CITY OF LATHRUP VILLAGE
PLANNING COMMISSION AGENDA

Site Plan Review

Site: 27208-27260 Southfield Road
Applicant: Lathfield Investments LLC
Plan Date: 4/7/2020
Zoning: MX- Mixed Use District
Parcel ID: 24-13-357-001; 24-13-357-002; 24-13-357-008
Proposal: 27206-60 Southfield Mixed Use

Site: 28600-28690 Southfield Road
Applicant: Lathfield Partners, LLC
Plan Date: 04/07/2020
Zoning: MX – Mixed Use District
Parcel ID: 24-13-105-001; 24-13-105-019; 24-13-105-017
Proposal: 28600-90 Southfield Mixed Use

LOCATION MAP
NO SCALE

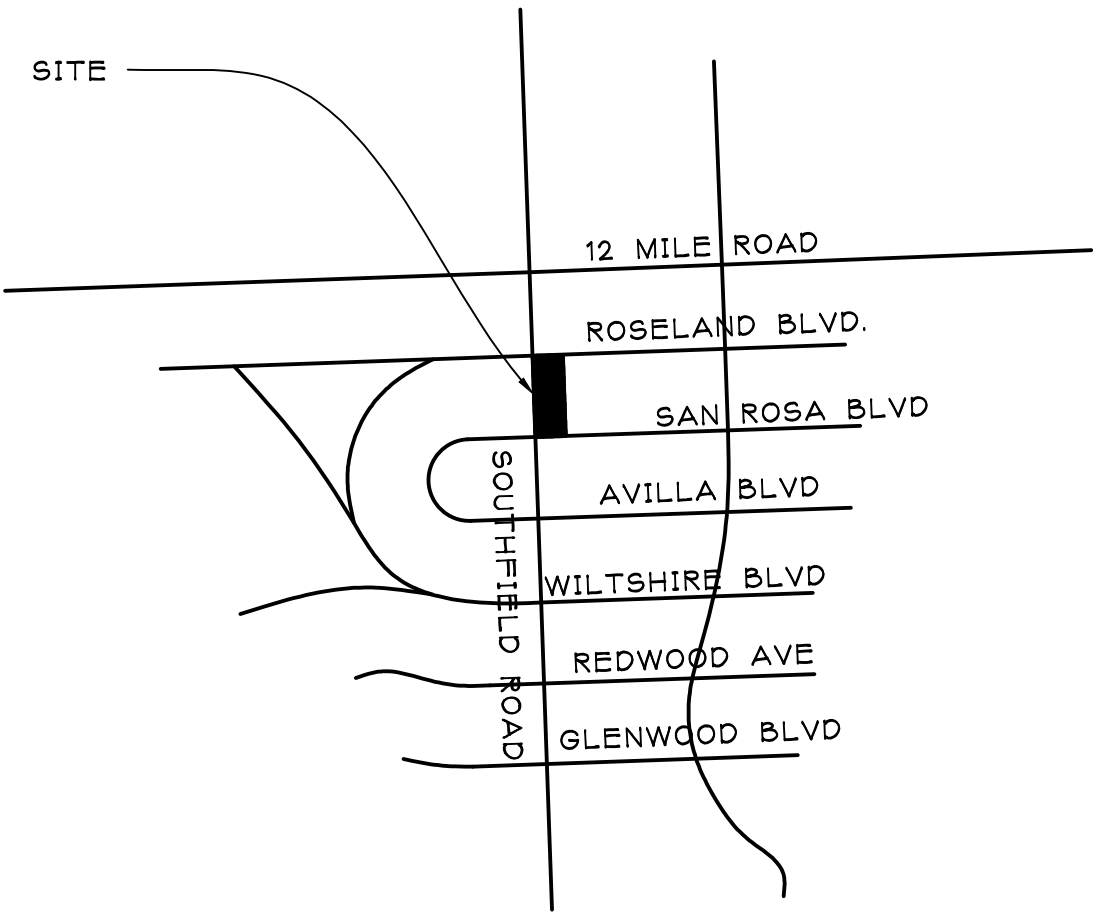
- a. The location map cited on the plan does not match the addresses noted in the application.

ARCHITECTURAL
SITE PLAN

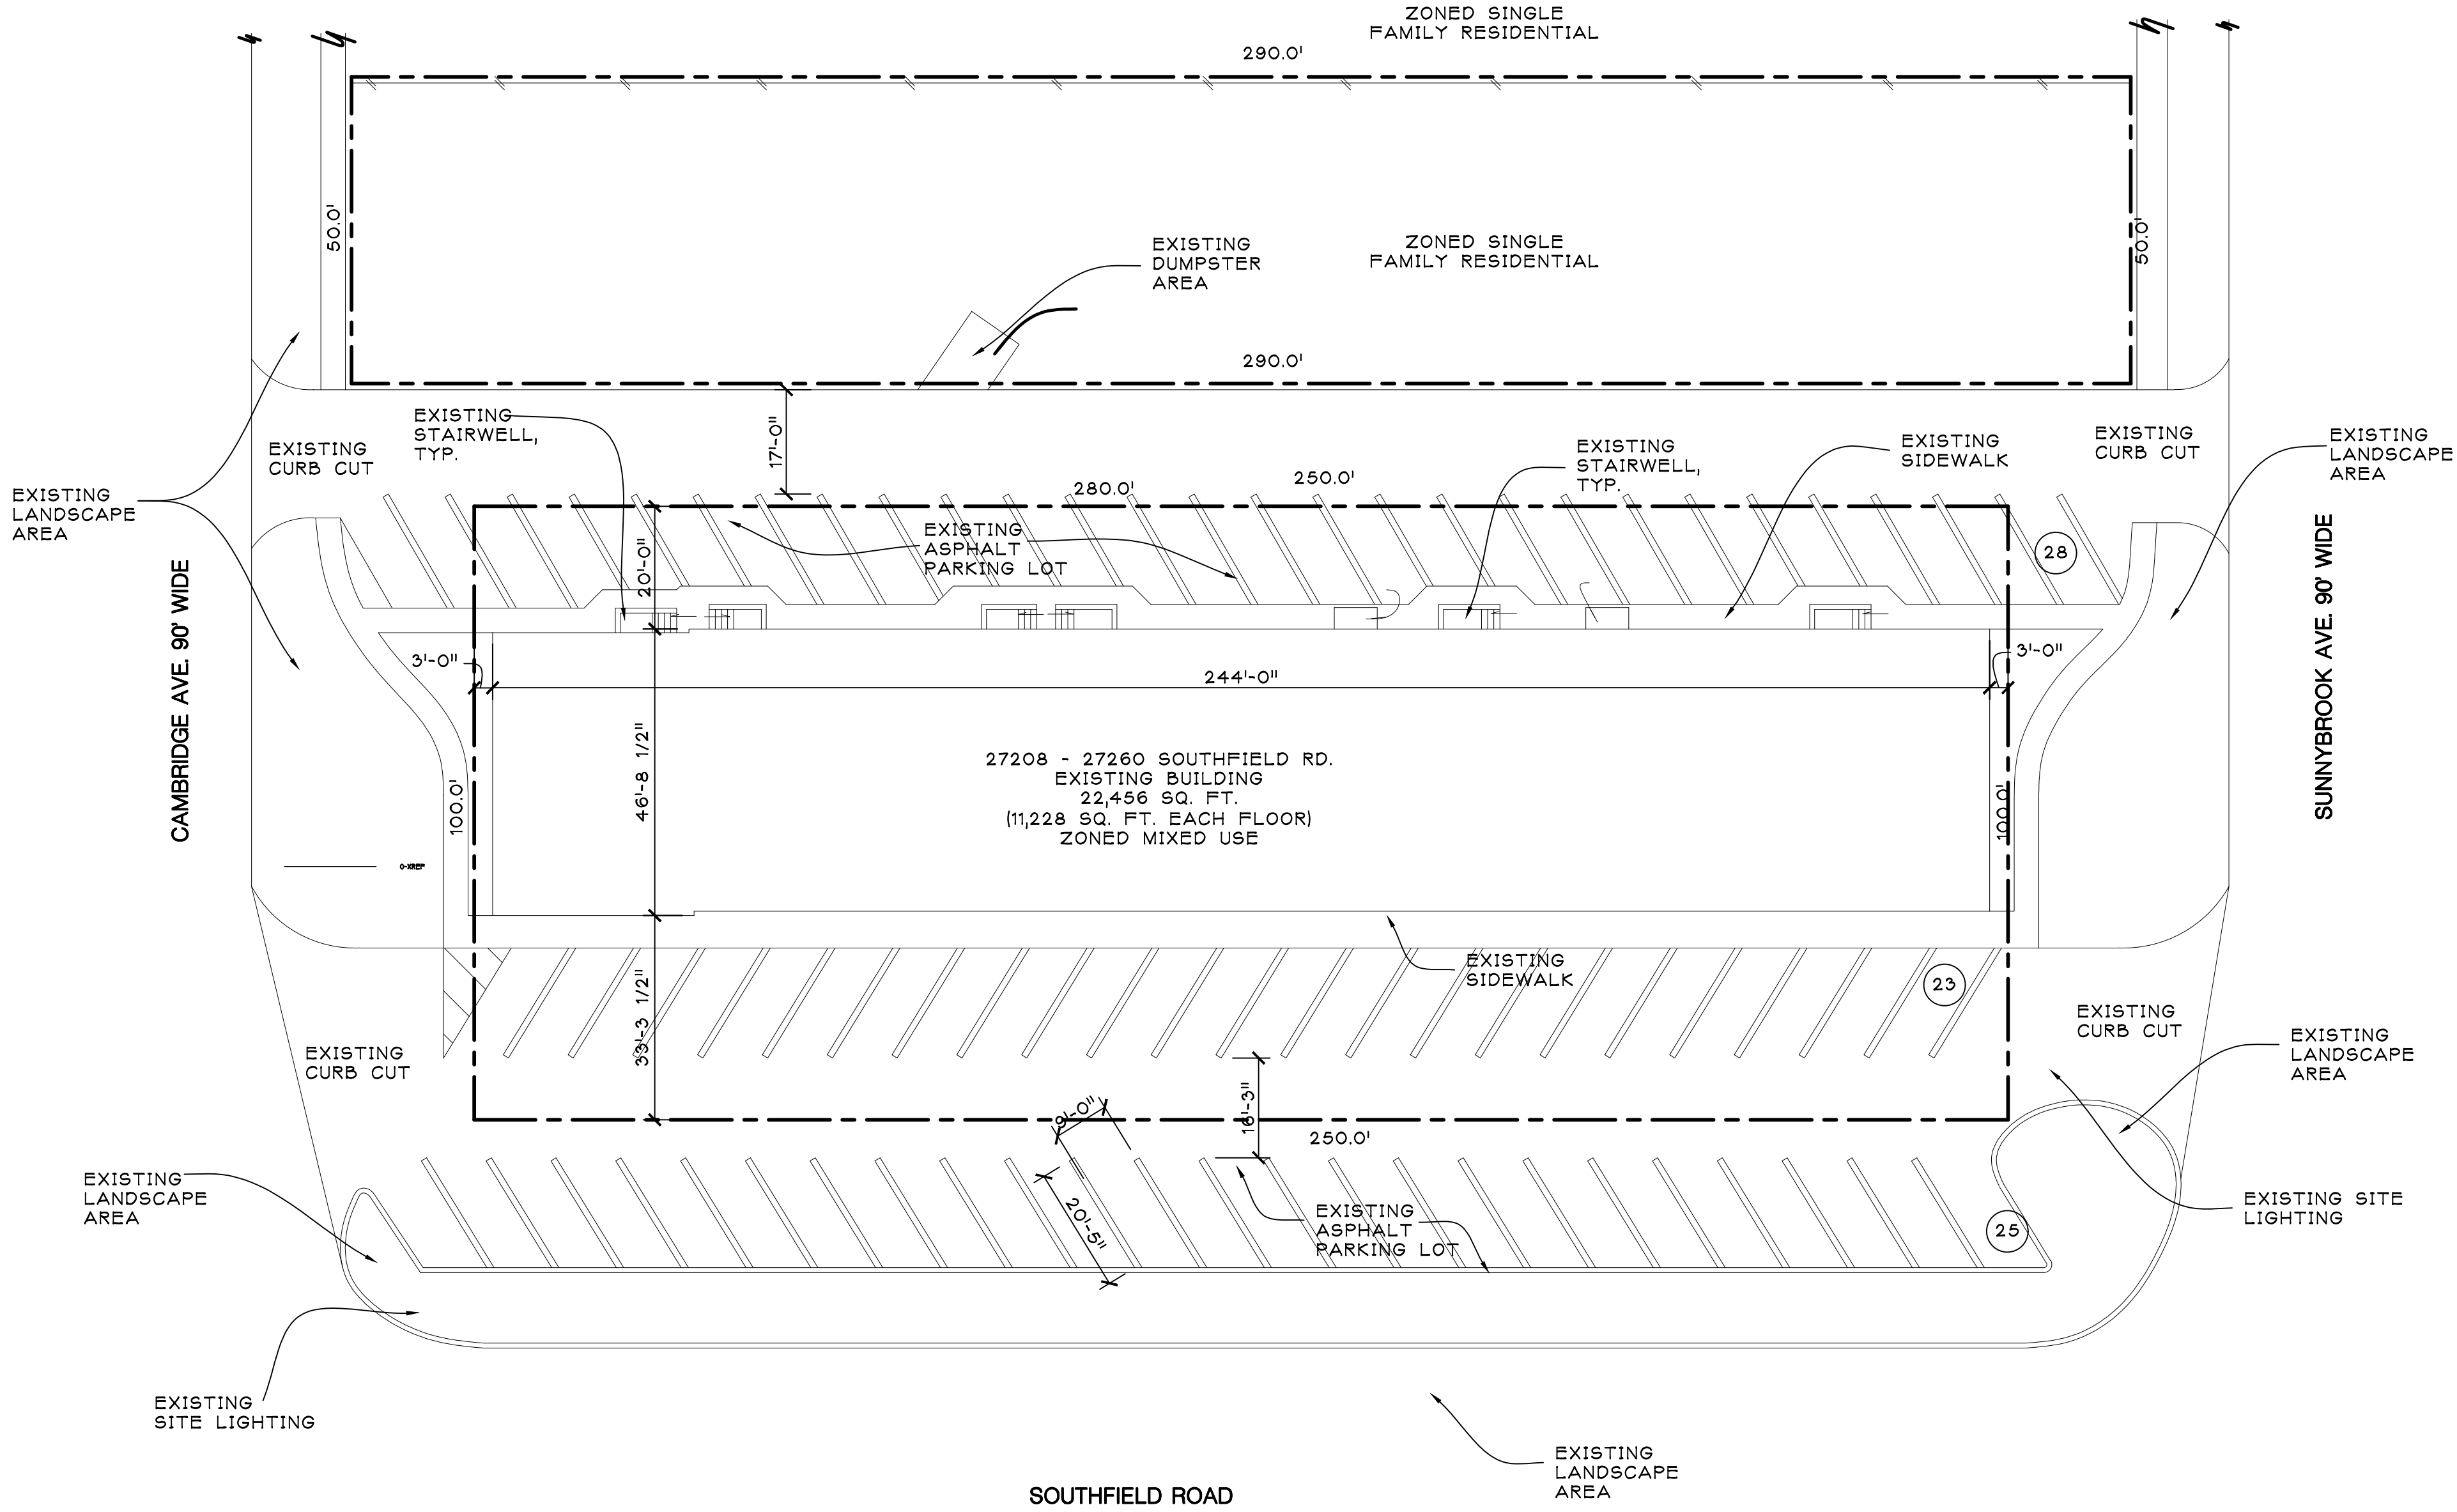
2. **Existing site.** The proposed site is currently comprised of a 0.9-acre parcel. The existing structure has two floors, each 11,228 square feet. The building fronts on Southfield Road and is 244 feet long. There are three existing landscaped areas located on the western portion of the site (buffering the parking lot from Southfield Road), and the north and south ends of the site. The applicant's site plan notes the alley is 17 ft wide, but parcel maps show the alley is 20 ft wide. **The applicant shall note the correct width of the alley.**

- b. Section 5.13.9.B. states where parking abuts a sidewalk or other pavement (seven-foot minimum width) two feet may be credited toward the total required parking space dimension. **The applicant seems to have utilized this two-foot overhang in the plan however the sidewalk abutting the parking is not seven feet in width therefore the sidewalk cannot be counted towards the required parking space dimension.**

8. **Loading.** Delivery vehicle space is required for sites that have buildings with a floor area over 3,000 square feet. **The proposed building is 22,456 square feet; therefore, one 40' x 10' space is required to be provided on site; no loading space is shown on the proposed plan.**

10. **Waste & Rubbish.** Plans indicate the existing dumpster enclosure will remain in the northeast corner of the rear parking lot, across the alley and on the R-1 zoned parcel. As presented, the proposed dumpster must meet the following site standards for waste and rubbish (section 5.3):

- c. **Bollards.** Bollards (concrete-filled metal posts) or similar protective devices shall be installed at the opening to prevent damage to the screening wall or fence. **No such bollards are indicated on the site plan.**

- a. **Landscape Plan.** No landscape plan was submitted with the application. Existing landscaped areas are shown, but existing trees, shrubs, and plant species are not indicated on the site plan. **Applicant shall provide a landscape plan to show existing and proposed landscaping on the site, if any.**
- b. *Minimum landscaped area of 5%.* **Applicant appears compliant but landscaped area coverage not indicated on the plan. Applicant shall confirm that at least 5% of the lot is landscaped.**

12. Screen Wall. Section 5.5 of the zoning ordinance outlines barrier wall requirements for MX lots that abut residential (R-1 or R-2) lots. **No barrier wall indicated on plan.**

ARCHITECTURAL
SITE PLAN

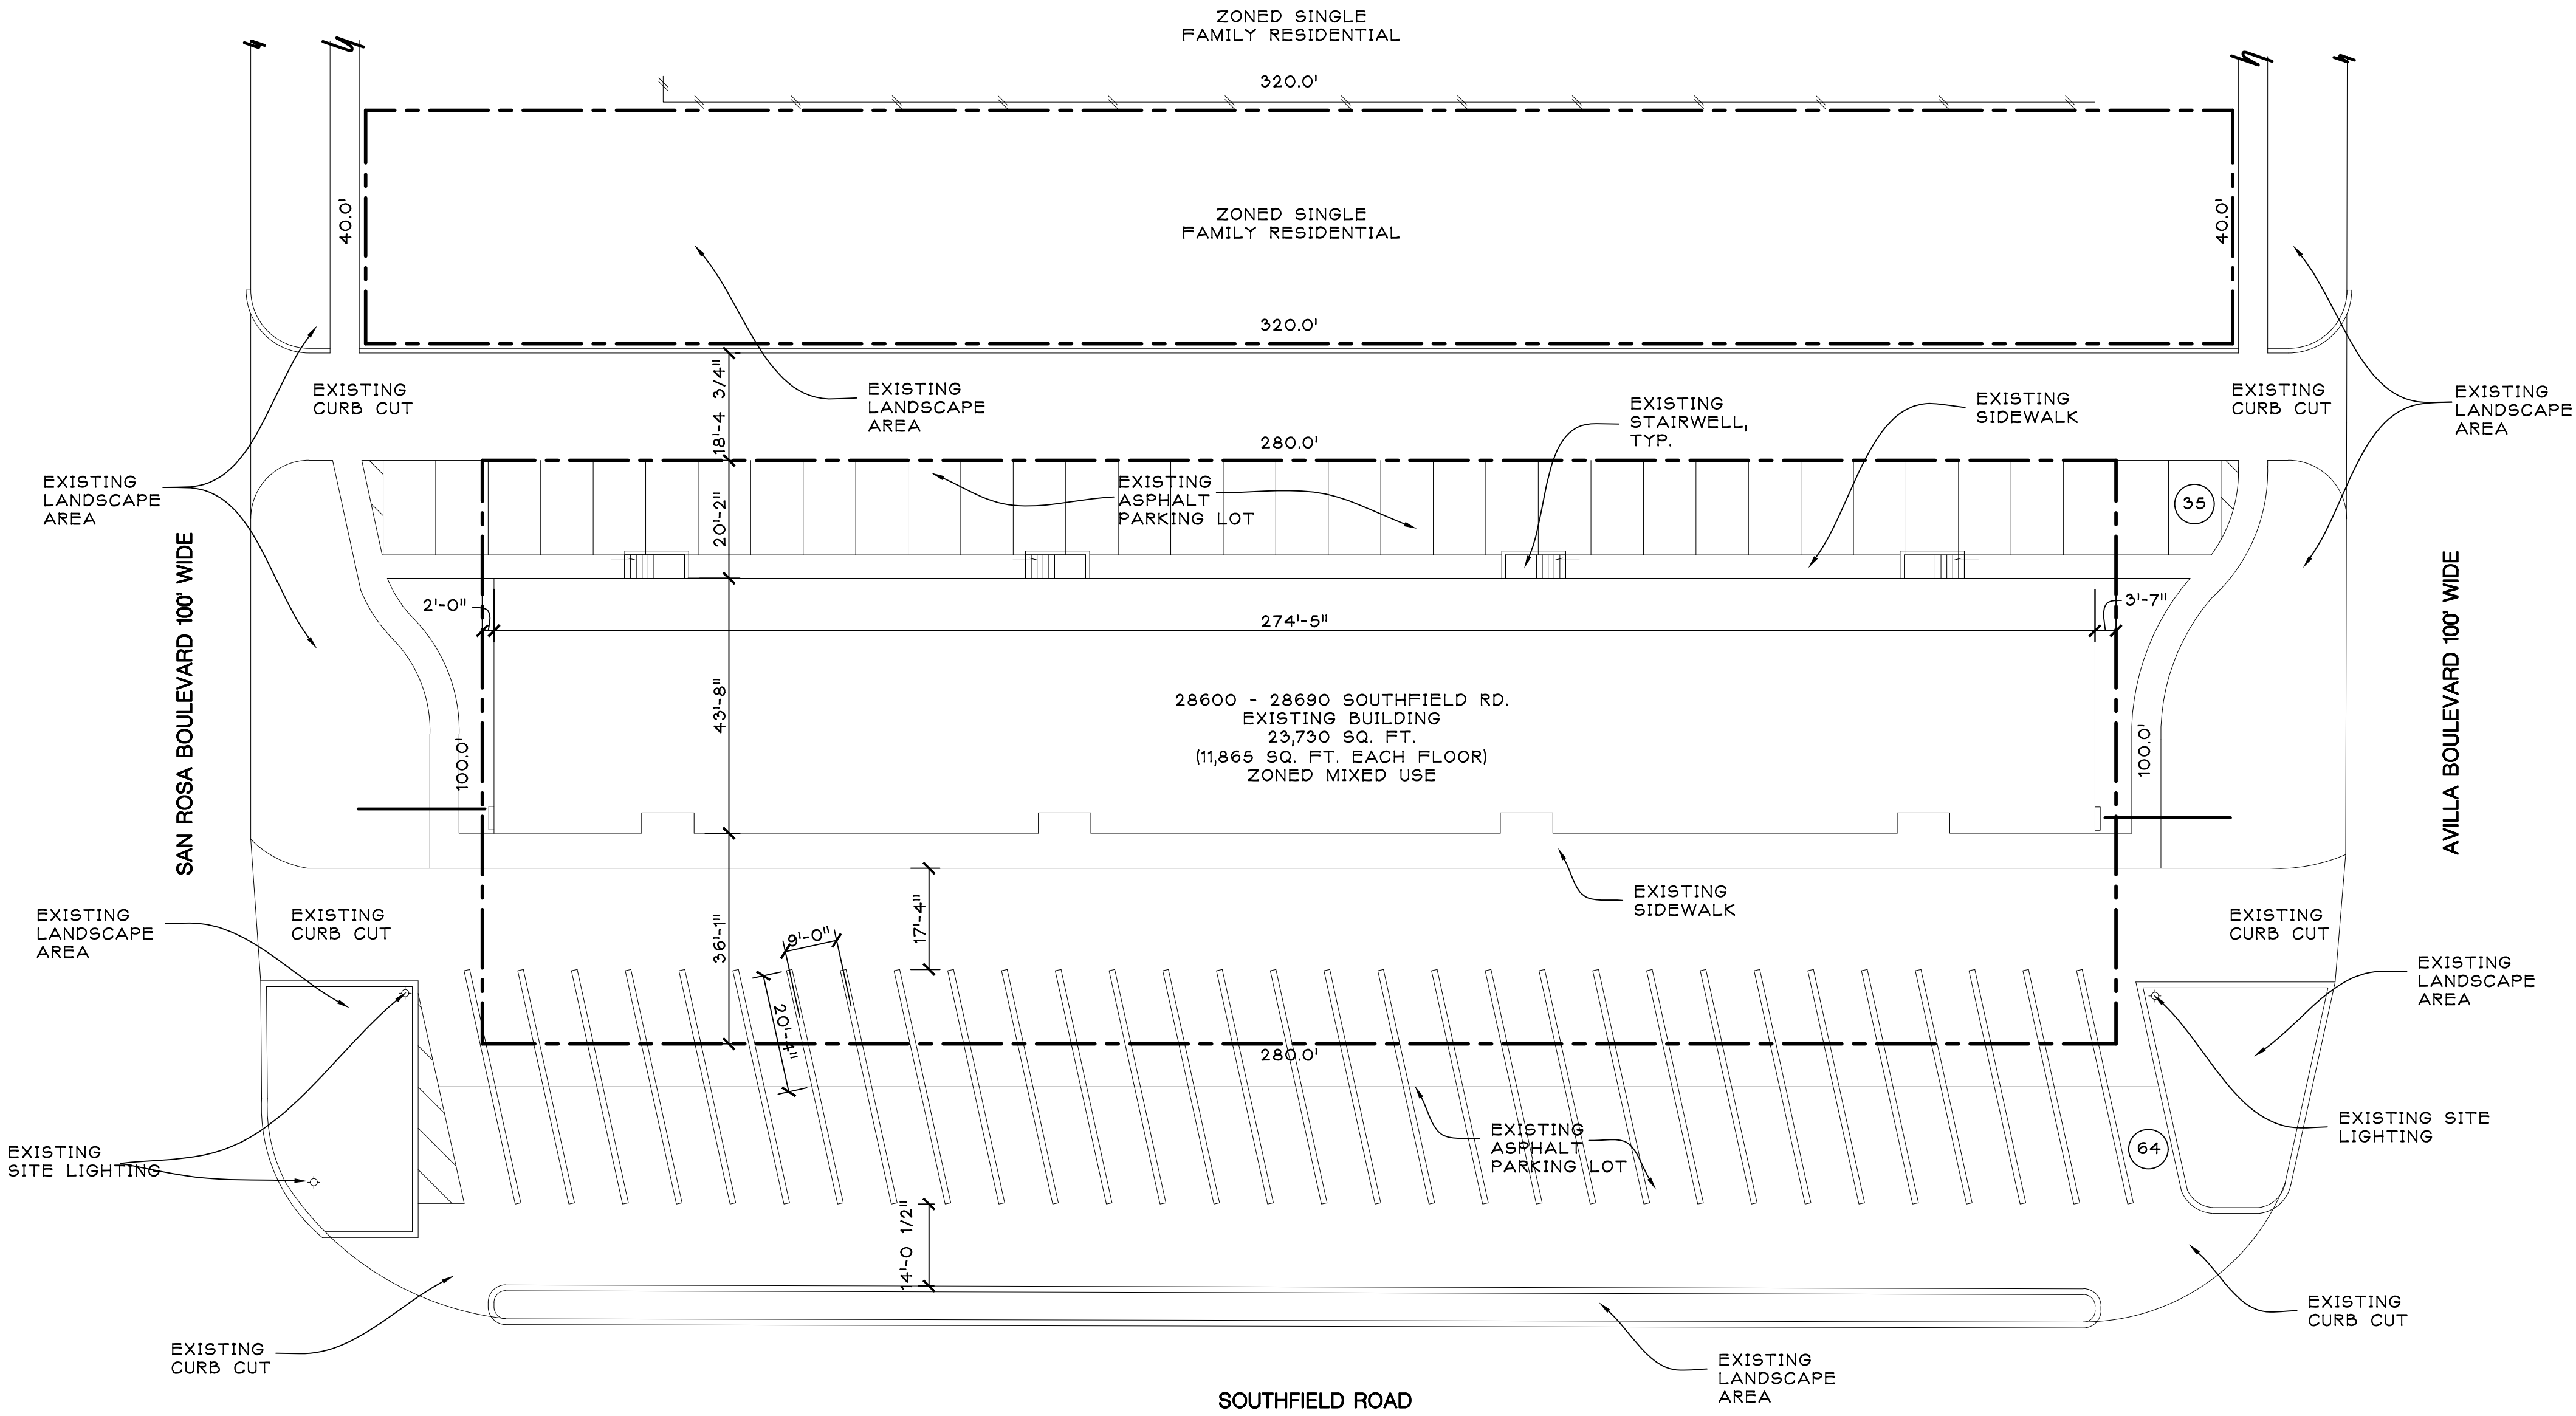
2. **Existing site.** The proposed site is currently comprised of a .94-acre parcel, including the residential parcels to the east of the building. The existing structure has two floors, each 11,865 square feet. The building fronts on Southfield Road and is 274 feet long. There are three existing landscaped areas located on the western portion of the site (buffering the parking lot from Southfield Road), and the north and south ends of the site. The applicant's site plan notes the alley is 18.5 ft wide, but parcel maps show the alley is 20 ft wide. **The applicant shall note the correct width of the alley.**

- b. Section 5.13.9.B. states where parking abuts a sidewalk or other pavement (seven-foot minimum width) two feet may be credited toward the total required parking space dimension. **The applicant seems to have utilized this two-foot overhang in the plan however the sidewalk abutting the parking is not seven feet in width therefore the sidewalk cannot be counted towards the required parking space dimension.**

8. **Loading.** Delivery vehicle space is required for sites that have buildings with a floor area over 3,000 square feet. **The proposed building is 23,730 square feet; therefore, one 40' x 10' space is required to be provided on site; no loading space is shown on the proposed plan.**

10. **Waste & Rubbish.** No dumpster is noted on the site plan; however, there is an existing dumpster on site that is not compliant. **The applicant shall confirm that the existing dumpster will be removed. If the dumpster is to remain, the following standards will apply:**

- a. Landscape Plan. No landscape plan was submitted with the application. Existing landscaped areas are shown, but existing trees, shrubs, and plant species are not indicated on the site plan. **Applicant shall provide a landscape plan to show existing and proposed landscaping on the site, if any.**
- b. *Minimum landscaped area of 5%.* **Applicant appears compliant but landscaped area coverage not indicated on the plan. Applicant shall confirm that at least 5% of the lot is landscaped.**

12. **Screen Wall.** Section 5.5 of the zoning ordinance outlines barrier wall requirements for MX lots that abut residential (R-1 or R-2) lots. It should be noted that the applicant owns the adjacent residential lot. **No barrier wall indicated on plan.**

LOCATION MAP
NO SCALE

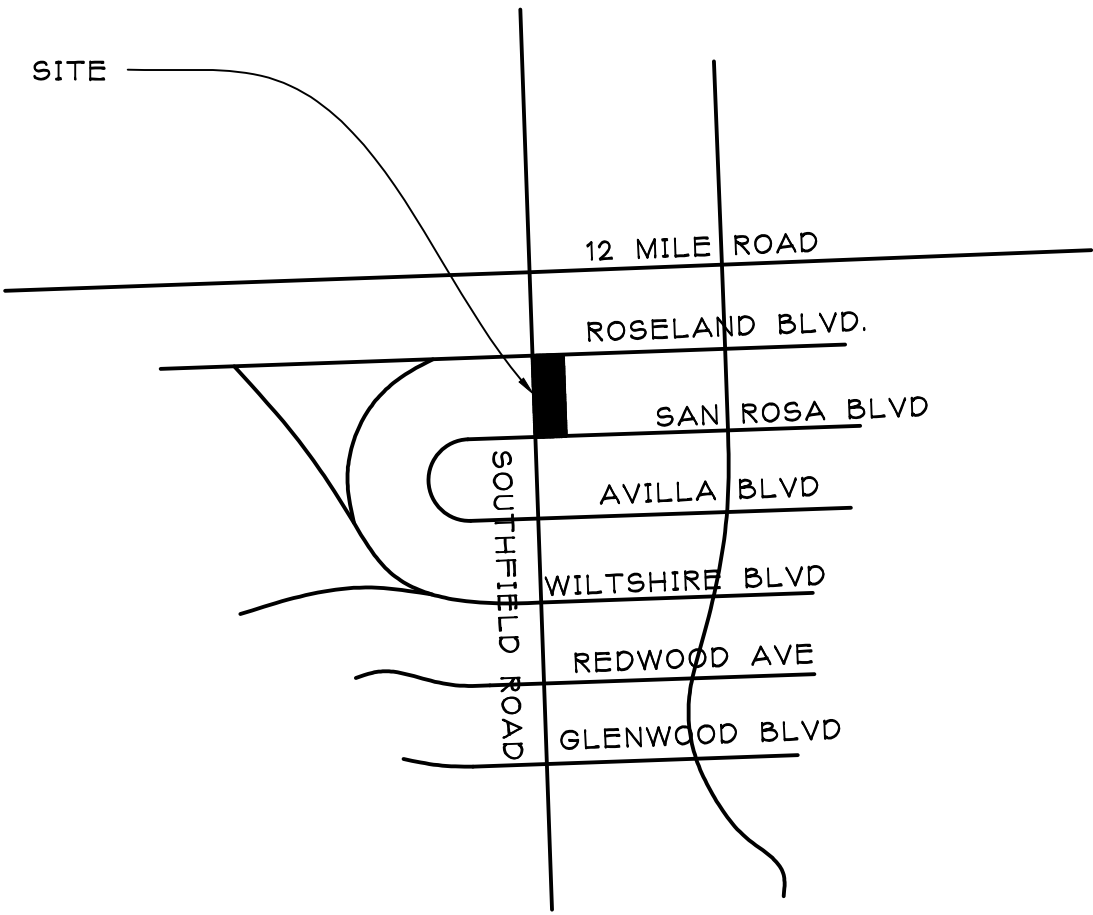
- a. The location map provided on the plan does not match the addresses listed for the site.
- b. The plan shows San Rosa Boulevard and Avilla Boulevard as the side streets but the address for the plan is located between San Rosa Boulevard and Roseland Boulevard.
